Subject: ICAP Comment Letter Response and Pilot Test Workplan Details
1630 Park Street, Alameda, CA
AEI Project No. 298931
ACEHD File No. RO0000008

AEI Consultants (AEI) has prepared this document as an addendum to the Interim Corrective Action Plan (ICAP) dated September 28, 2011 and to address the comments outlined in the Alameda County Environmental Health Department (ACEHD) letter dated November 4, 2011 (hereinafter referred to as the "letter"). AEI has been retained by Foley Street Investments, LLC, owner and developer of the site, to provide environmental engineering and consulting services relating to the above referenced fuel leak case. Responses to items in the letter are presented below. The reader is referred to the above referenced letter and ICAP document for details and original comments.

Proposed Remediation Wells	
1600 - 1630 PARK STREET ALAMEDA, CALIFORNIA	
FIGURE 9	
JOB NO: 298931

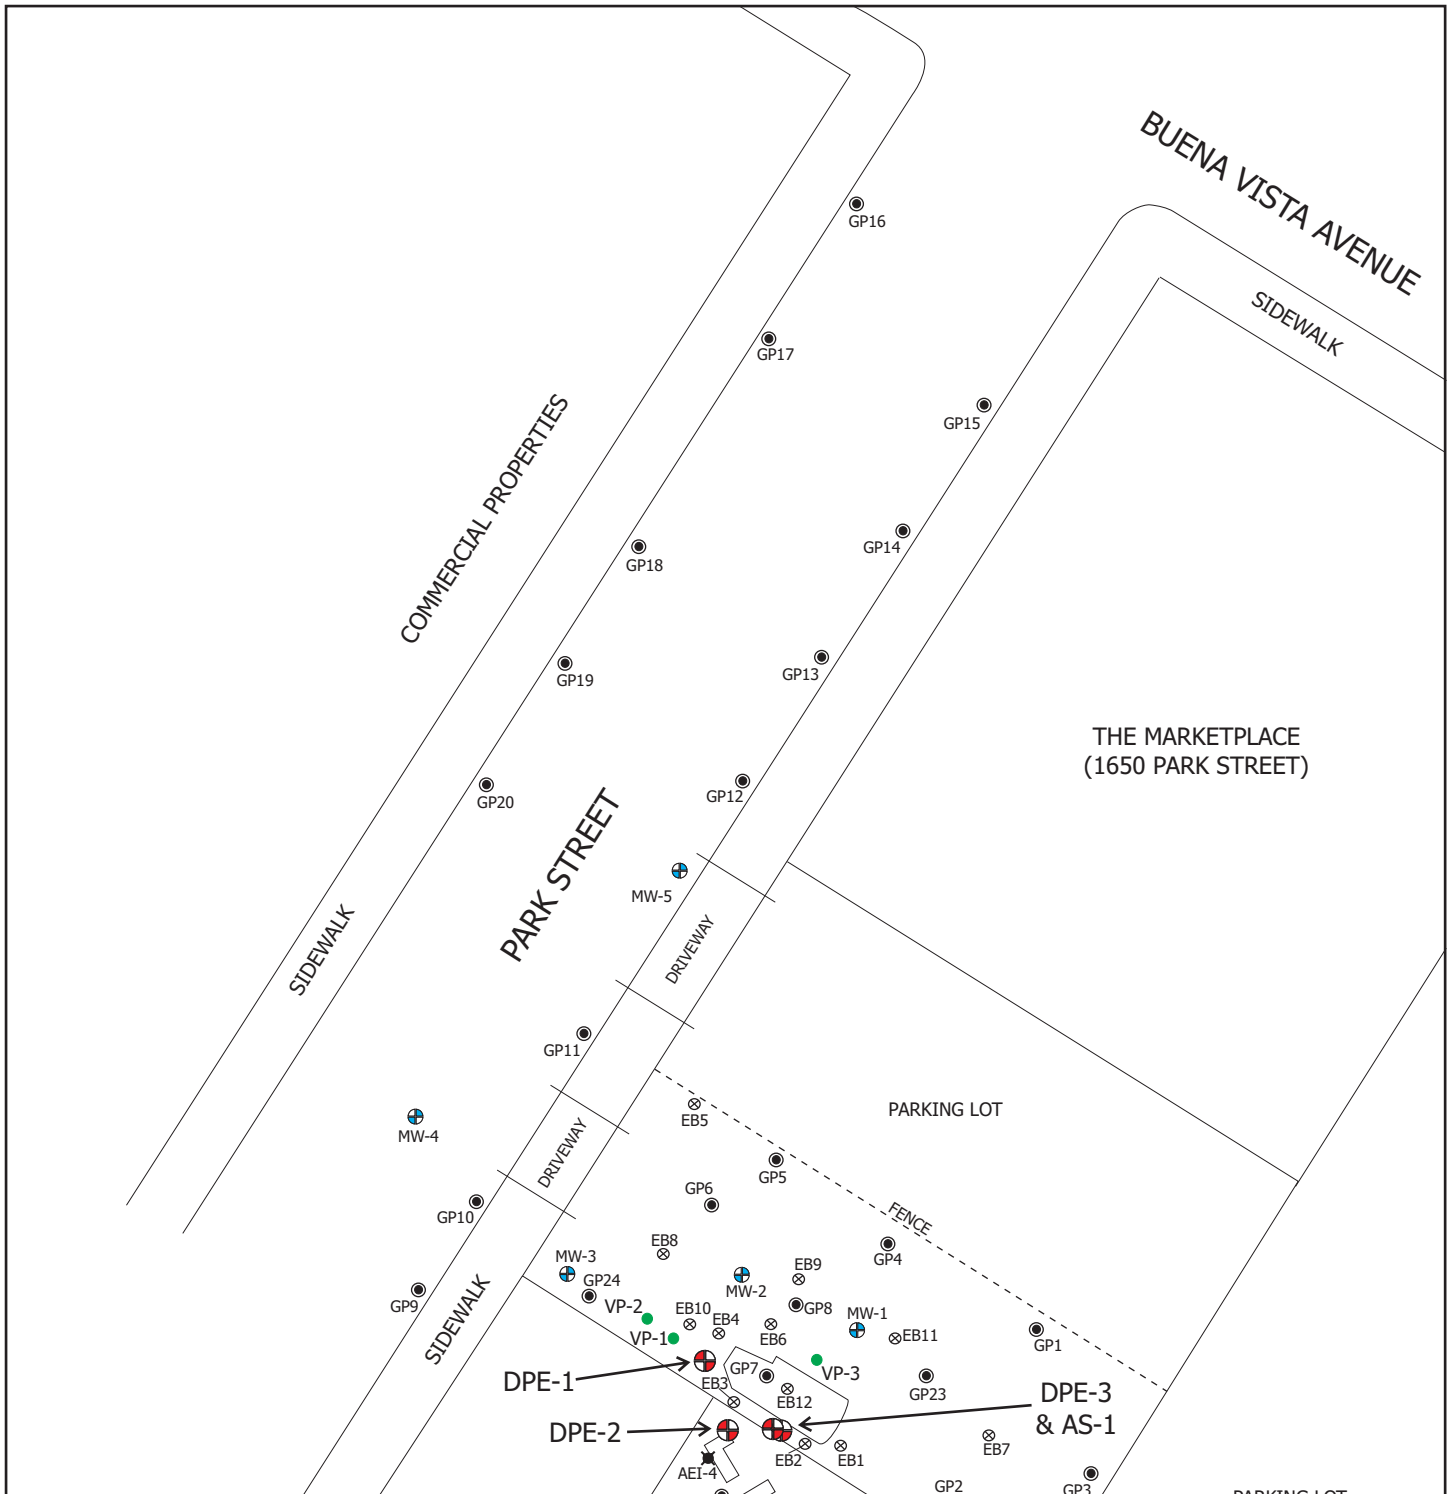
The three vapor monitoring probes (VP-1 to VP-3) noted in the above table are shown on revised Figure 9 (attached). These probes will be installed prior to the pilot test. Each probe will be installed in small diameter geoprobe type borings to a depth approximately 5 feet (just above the capillary fringe) and will be constructed of a ¼ inch stainless steel or poly tubing with an approximately 6 inch screen on the bottom. The annulus around and to approximately 6 inches above the screen will be filled with sand pack, above which the temporary probe will be completed with a hydrated bentonite seal to the surface. The probes will be used to collect induced vacuum measurements at distances of 5 and 10 feet (VP-1 and VP-2, respectively) from DPE-1 and across the former tank hold (VP-3) to evaluate possible effects of the backfill material on induced vacuums. Upon completion of the pilot test, it is planned that
